# Detailed Site Plan Type 2 Tree Conservation Plan Swann Crossing

**DSP-23019**  
**TCP2-036-2024**

SUBJECT: Detailed Site Plan DSP-23019  
Type 2 Tree Conservation Plan TCP2-036-2024  
Swann Crossing

Figure 1: Site Plan

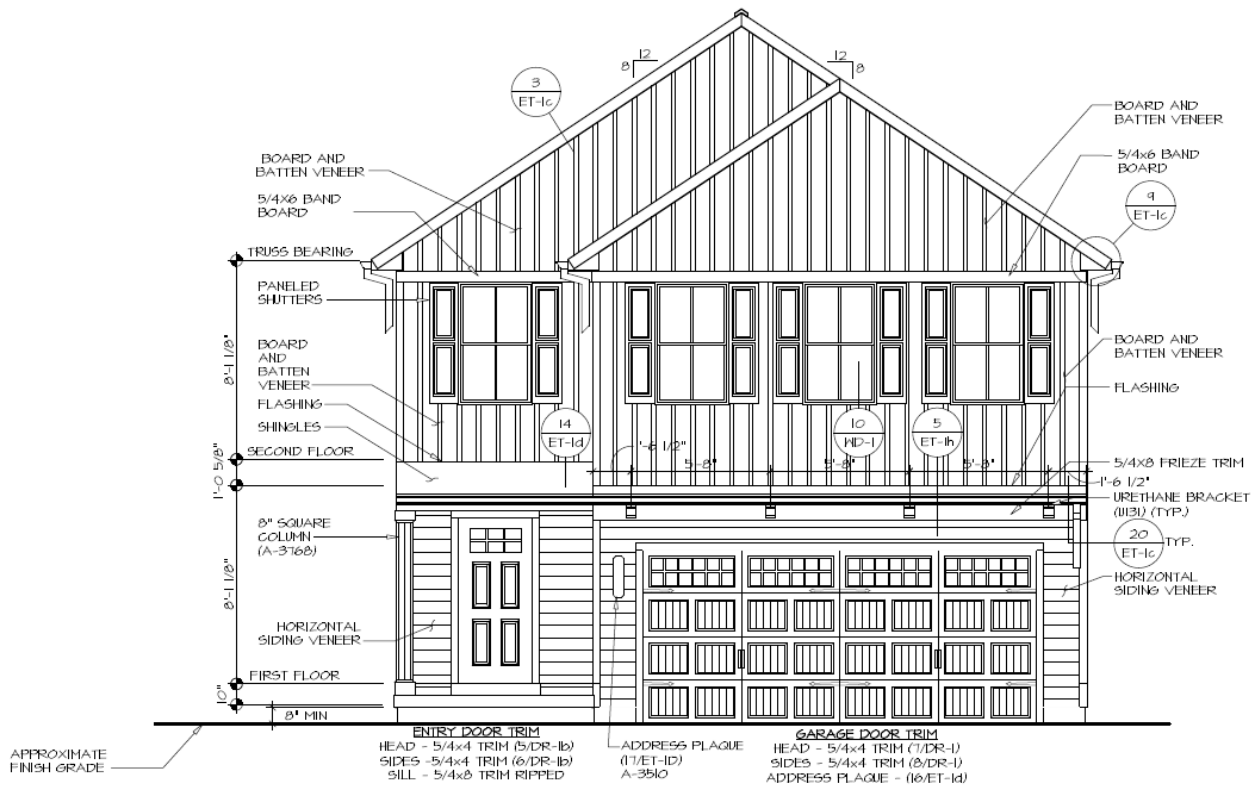
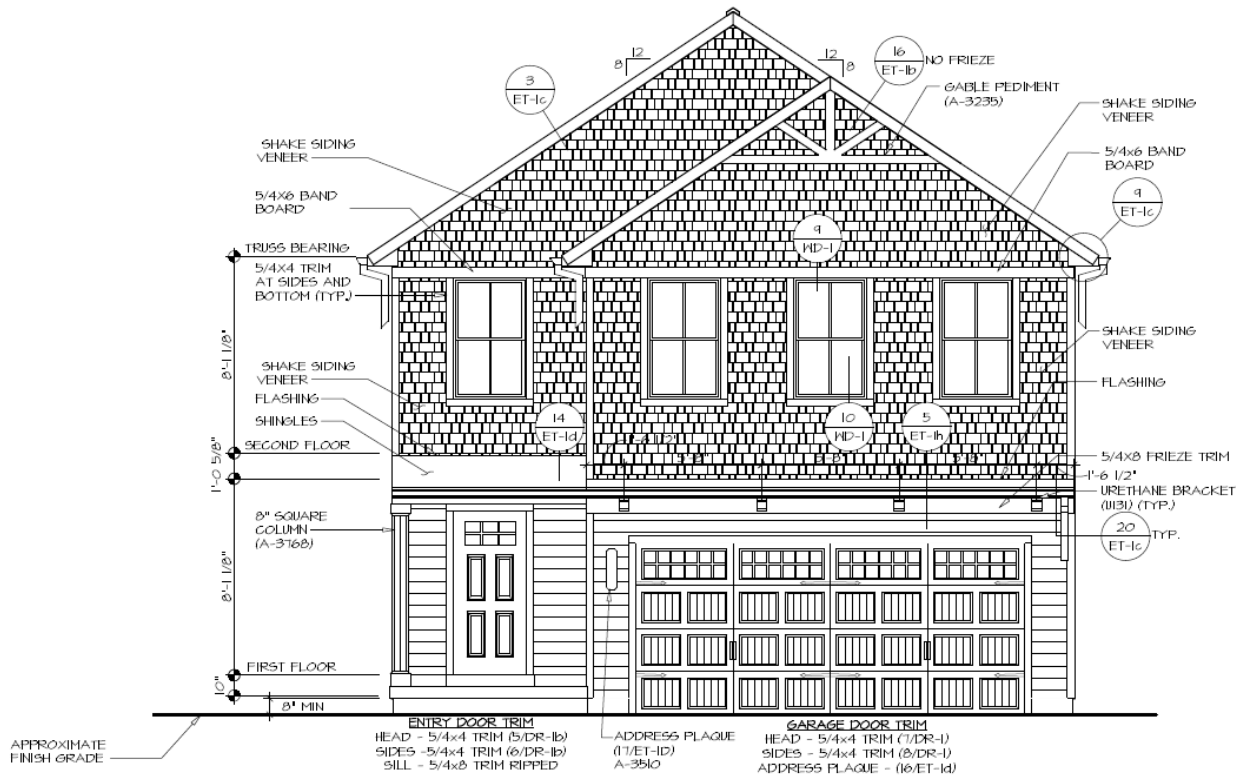
Three bike racks are shown at the recreation area. However, these racks are not labeled, and no detail is provided. A condition is recommended to label the bike racks and provide a detail for inverted-U shaped racks.

**Signage:** Two entrance, monument signs, are shown on the plans. The 5-foot-high by 2-foot, 6-inch square entrance features will have stone veneer and a precast concrete cap, with an 18-inch-wide by 16-inch-high sign plate. A condition has been recommended to dimension the distance of the monument signs from the right-of-way (ROW).

- a. Label the three bike racks and provide a detail for an inverted U-style or similar model that provides two points of contact for a parked bicycle.

- d. Label the 6-foot-high wood fence on the plan.
  - e. Provide at least one additional inclusive piece of equipment in the recreation area.
  - f. Dimension the distance of the monument signs from the right-of-way.
